# Access Compliance Report

## Public Rights-of-Way

Intersection ID: 44734	Main Street: MCCHESEY_DR	Cross Street: SIGNATURE_RIDGE_RD	Location: W
ADA ID: 6ECE56B3A201	Ramp Type: Perp	Initial Pass/Fail: Fail	Overall Compliance: No
Severity Score: 46.25			
Codes/Mitigation Info/Possible Solution		Field Measurements/Component Compliance

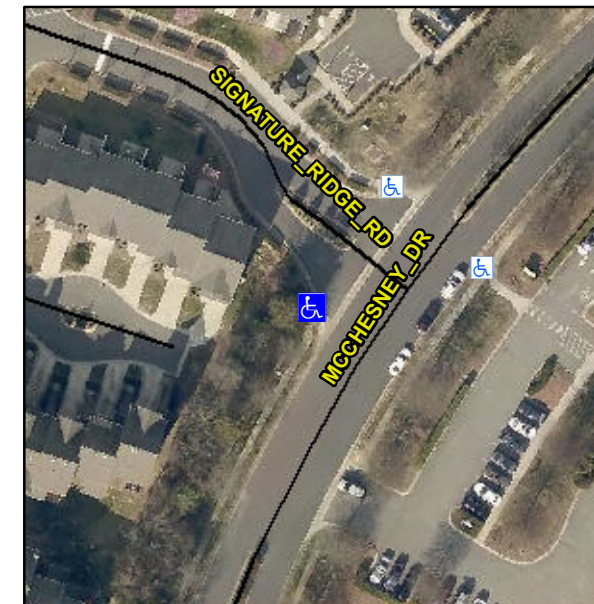
**R304.5.1, R304.2.2, R304.5.3**

Compliance	Description	Data	Compliance	Description	Data
N/A	Ramp Length (in)	48.0	No	Ramp Slope (%)	9.7
No	Ramp Width (in)	47.5	No	Ramp XSlope (%)	7.4
N/A	Flare Type LT	N/A	N/A	Flare Type RT	N/A
N/A	Flare Slope LT (%)	N/A	N/A	Flare Slope RT (%)	N/A
N/A	Flare Traversable LT?	N/A	N/A	Flare Traversable RT?	N/A
N/A	Landing Length (in)	N/A	N/A	DWS Provided?	N/A
N/A	Landing Width (in)	N/A	N/A	DWS Contrast?	N/A
N/A	Landing Slope (%)	N/A	N/A	DWS Length (in)	N/A
N/A	Landing X Slope (%)	N/A	N/A	DWS Full Width?	N/A
N/A	Landing Curb? (Y/N)	N/A	N/A	DWS Offset (in)	N/A
N/A	Shared Landing?	N/A			
N/A	Gutter Ponding?	N/A	N/A	Gutter Slope (%)	N/A
N/A	Gutter Lip Ht (in)	N/A	N/A	Gutter X Slope (%)	N/A
N/A	Painted X Walk1?	No	N/A	Painted X Walk2?	N/A
	X Walk 1 Direction	To NE		X Walk 2 Direction	N/A
N/A	X Walk 1 Width (in)	N/A	N/A	X Walk 2 Width (in)	N/A
	X Walk 1 Slope (%)	4.1		X Walk 2 Slope (%)	N/A
	X Walk 1 X Slope (%)	3.0		X Walk 2 X Slope (%)	N/A

**Remove & Replace Entire Ramp.**
